City of Glendale
Community Development Department
Design Review Staff Report – Single Family

Meeting/Decision Date: February 24, 2020	Address: 2181 E. Chevy Chase Drive
Review Authority: <input type="checkbox"/> DRB <input checked="" type="checkbox"/> ADR <input type="checkbox"/> HPC <input type="checkbox"/> CC	APN: 5663023063
Case Number: PDR 1918507	Applicant: Claudia Pizarro
Prepared By: Milca Toledo, Senior Planner	Owner: Jose Antonio Flores and Young Choi

Flores - Choi
Residence
2181 E. Chevy
Chase Dr.
Glendale, CA
91206

A1.1

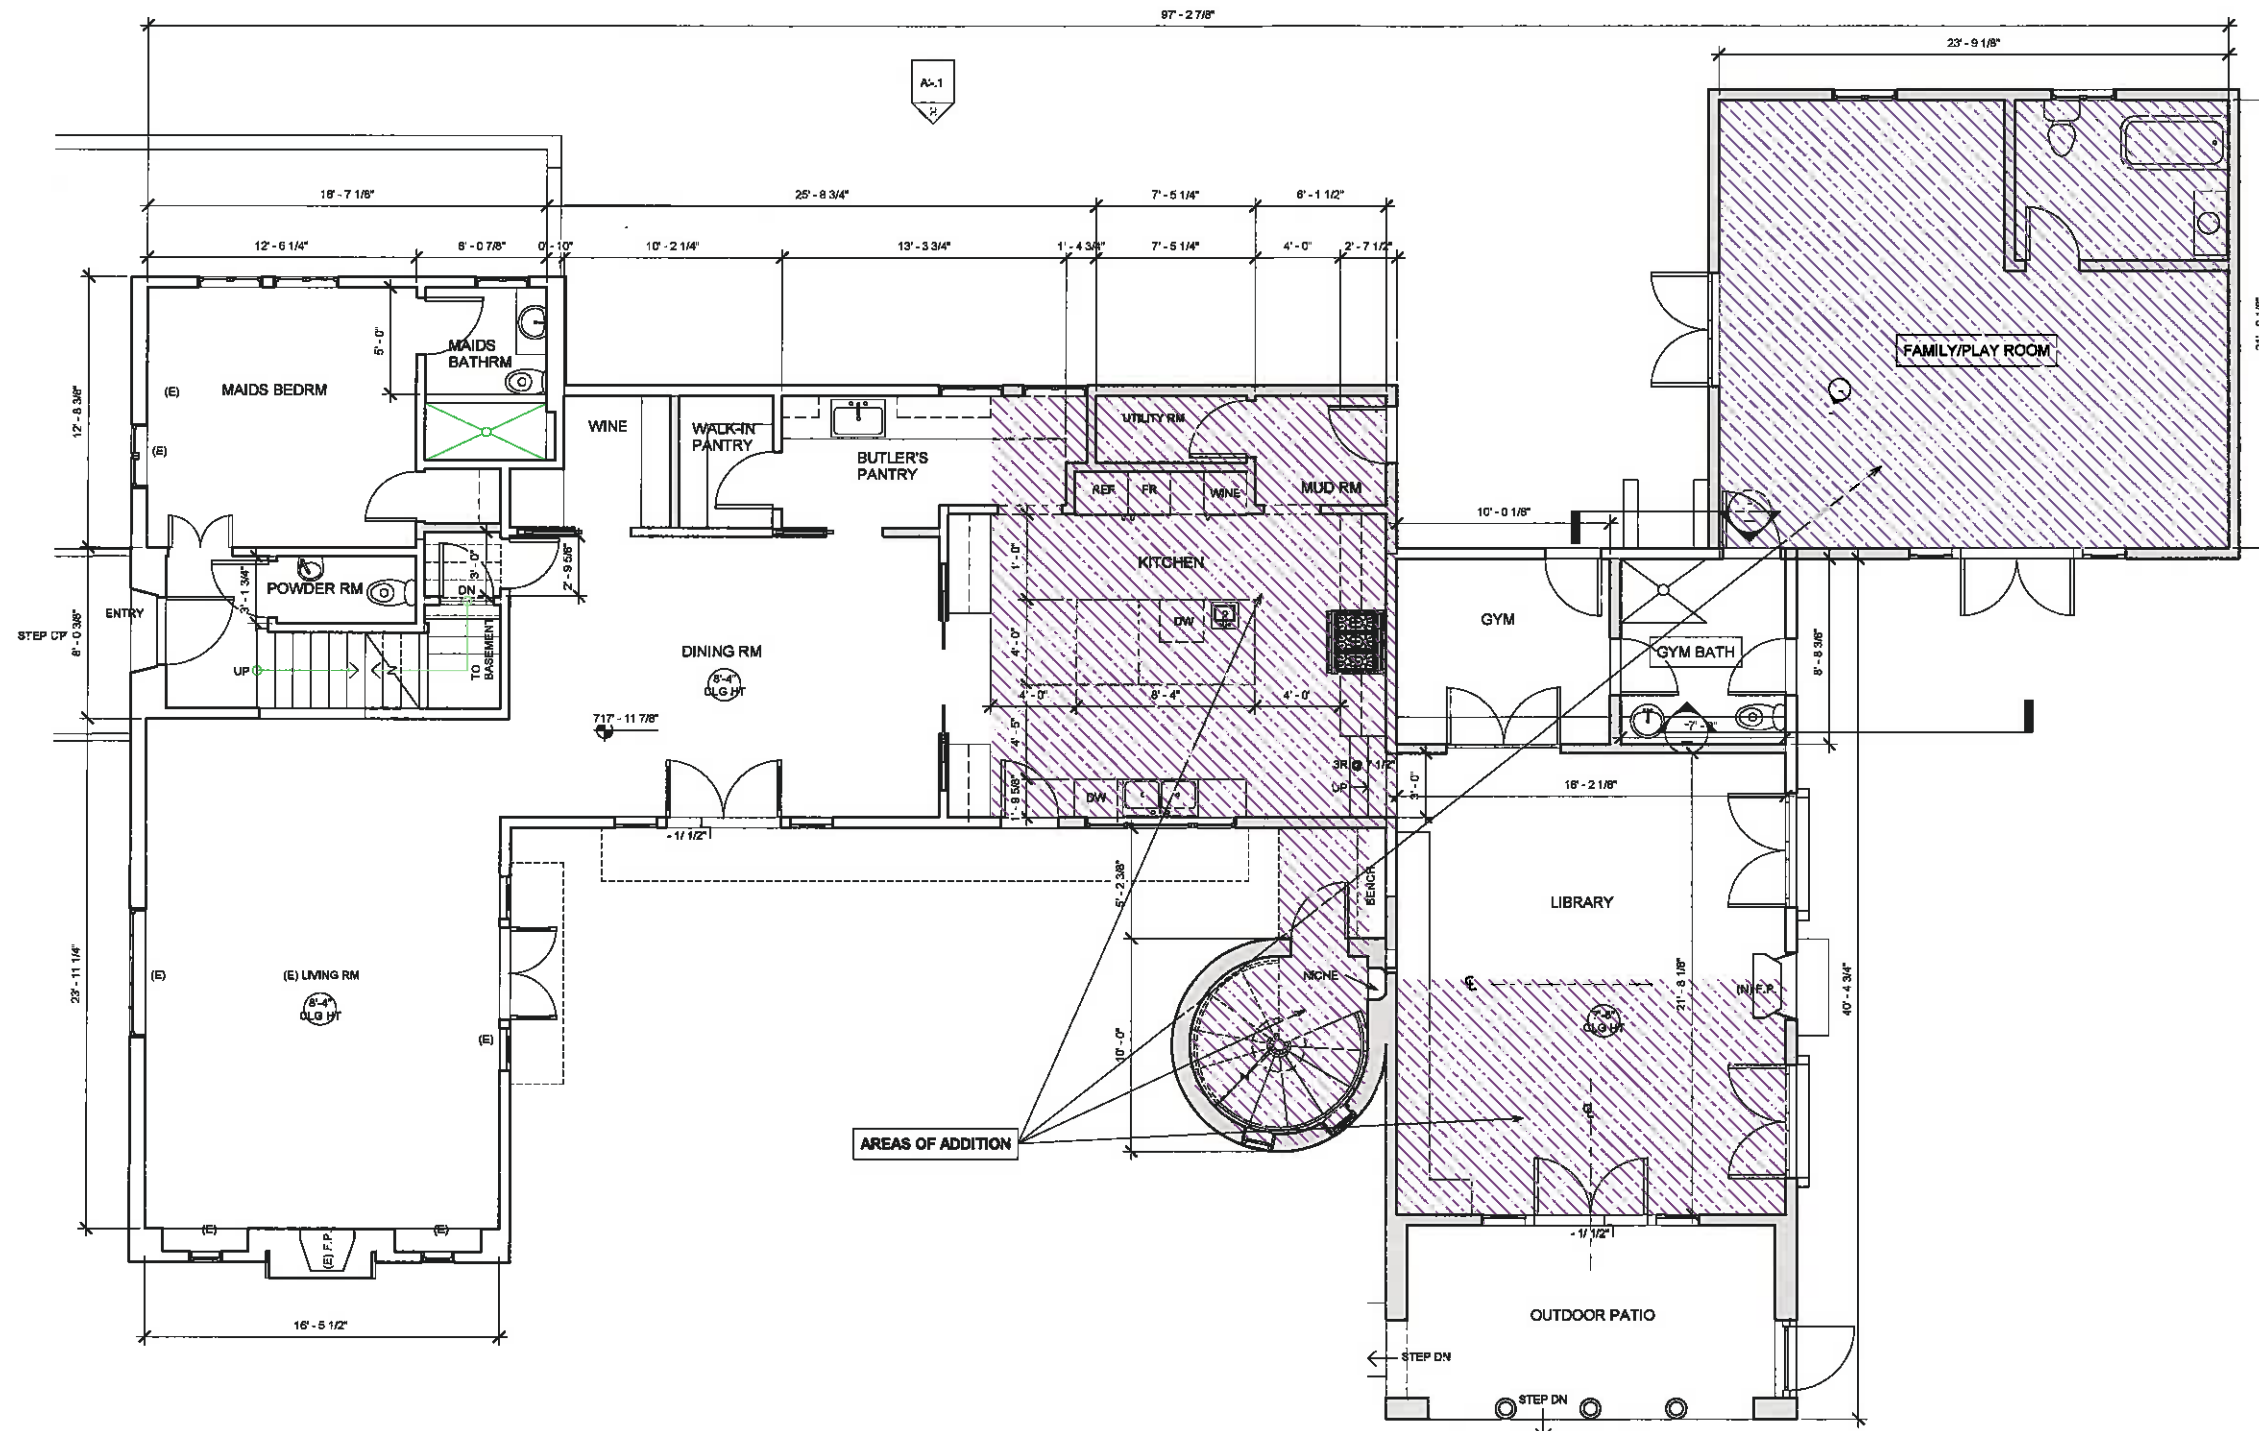
6. That the existing chainlink fence located at the front of the property be removed or replaced with a style that is complementary to Spanish Revival architecture and does not encroach into any required street front setback areas.

12. Show an appropriate designated trash storage area on the site plan.
13. Show an appropriate designated mechanical equipment area on the site plan.

DRAWING TITLE Window Detail Dbl. Casement 1x3 Nastrim	
SCALE 	
DATE Issue Date 	
CADD FILE :	PROJECT NUMBER 398
SHEET NUMBER	
<div style="font-size: 48pt; font-weight: bold;">A3.18</div> <div style="font-size: 10pt; margin-top: 10px;">COPYRIGHT © 2002 Xcelia</div>

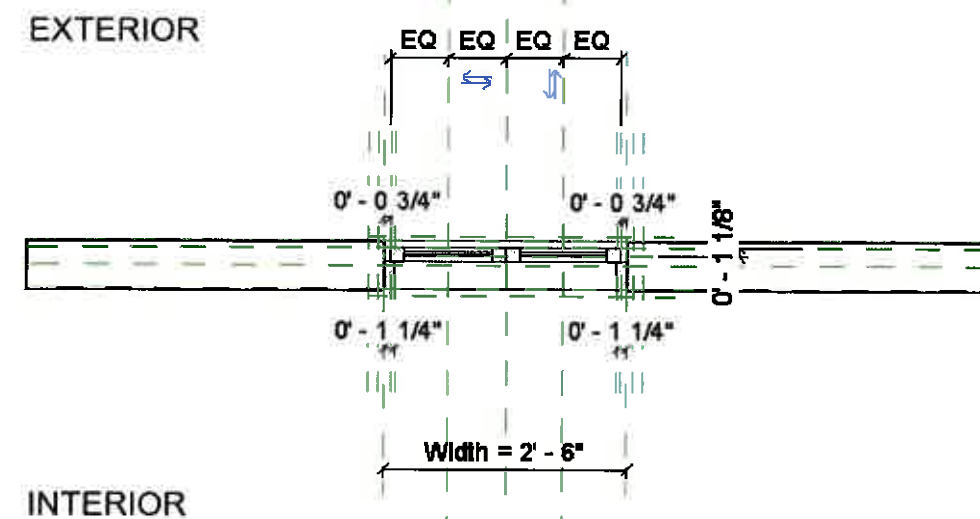
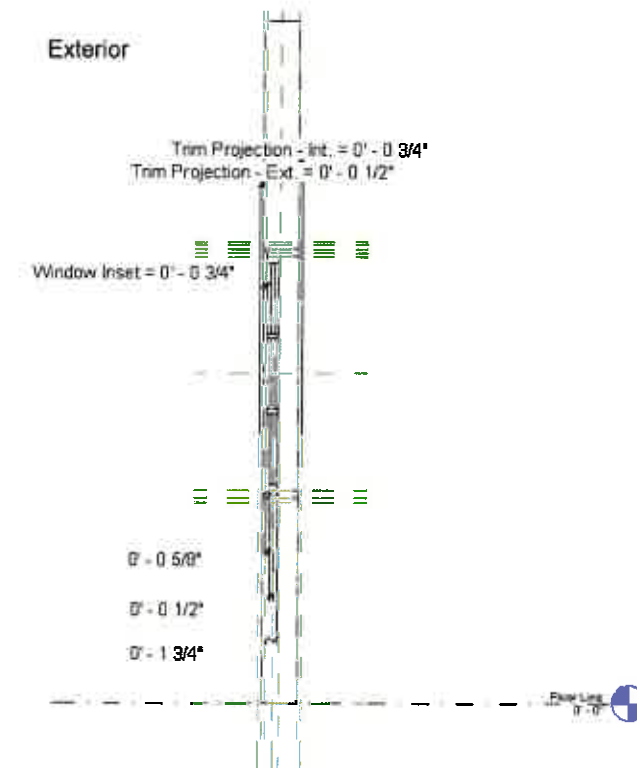
1. Submit a window detail showing new and replacement windows recessed within the openings and constructed with a wood frame and sill underneath.
2. Revise the window grid pattern shown on sheets A3.18 and A3.19 to reflect the grid pattern shown on the elevation drawings, which is appropriate to the style of the house.
